BUILDING CODE OF AUSTRALIA COMPLIANCE ASSESSMENT REPORT

MAIN WORKS FOR WATERLOO MIXED USE DEVELOPMENT (HDA) - SSD-80441462

881-885 BOURKE STREET, WATERLOO

REPORT NO. ► 13143.9

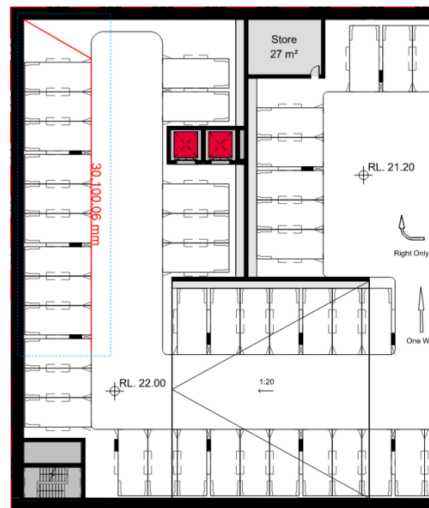
NSW D2D3 Number of exits required [2019: D1.2]	▪ The architect is to detail egress doorways to the following areas: ○ Loading dock and waste areas on the ground floor of Building 3A; ○ The gym on the ground floor of Building 3A/3B; ○ Ground floor retail space in Building 2A.  ▪ The following areas are not provided with a second exit: ○ Building 2A – level 01 to level 6;

BCA Clause	Deemed-to-Satisfy Provision to be addressed
	 This is to be addressed by way of a Performance Solution by the fire engineer at CC stage. Details demonstrating compliance with this clause must be incorporated into the construction certificate plans / specification
D2D5 Exit travel distances [2019: D1.4]	The following areas exceed the maximum travel distance to an exit/s: - Basement 01 & 02 – Up to 21m to a point of choice to 2 exits in lieu of 20m from the furthest point within the store room;  - Basement 01 – Up to 30m to a point of choice to 2 exits in lieu of 20m;

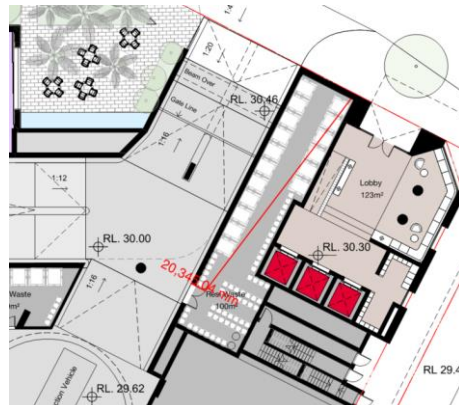
- Basement 02 – Up to 30m to a point of choice to 2 exits in lieu of 20m;

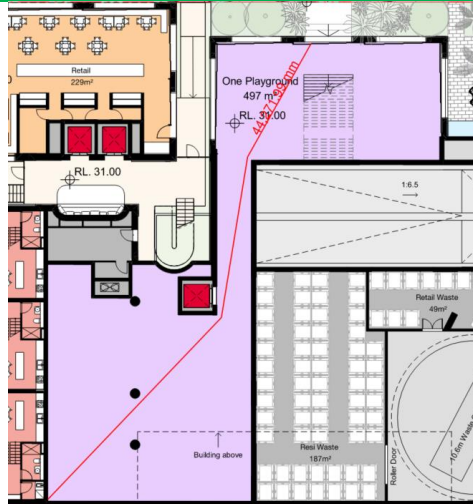
- Ground floor (Building 3A) – Egress doorways to be detailed to the loading dock area. Currently, up to 20.3m from the furthest point within the waste room to the doorway opening to the loading dock.

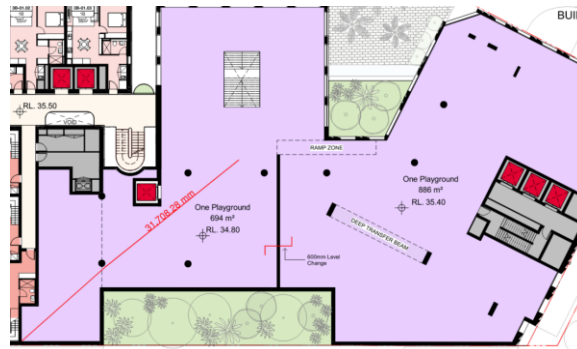
- Ground floor – Up to 45m to an exit in lieu of 20m from the furthest point within the gym tenancy;

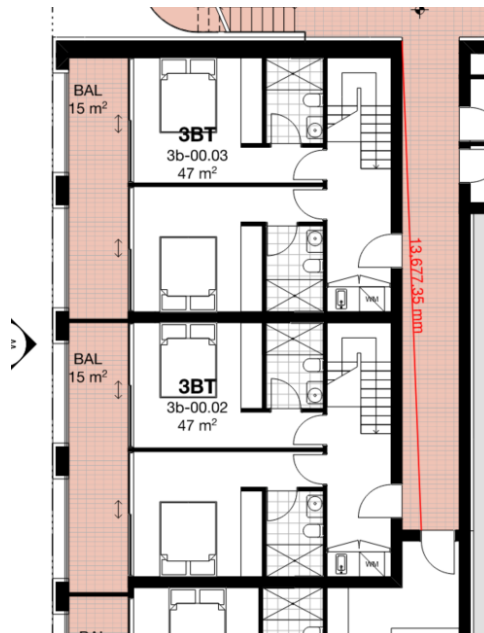
- Level 01 to level 6 (Building 2A) – Up to 10.5m to an exit in lieu of 6m from the doorway to the furthest unit;

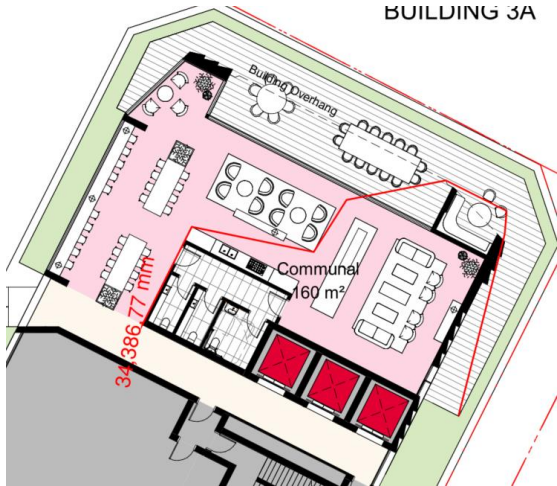
- Level 01 (Building 3B) – Up to 13.7m to a point of choice to 2 exits in lieu of 6m;

- Level 02 to level 04 (Building 3B) – Up to 11.2m and 12.4m to a point of choice to 2 exits in lieu of 6m;

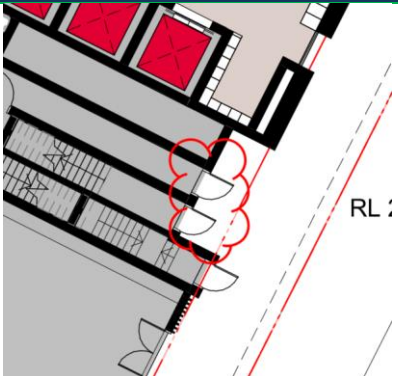
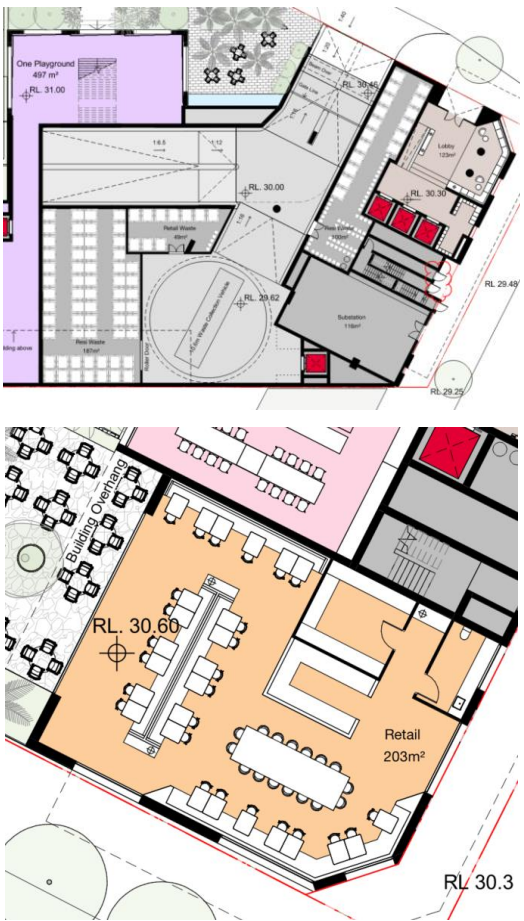
- Level 05 to level 06 (Building 3B) – Up to 8.5m and 12m to a point of choice to 2 exits in lieu of 6m;
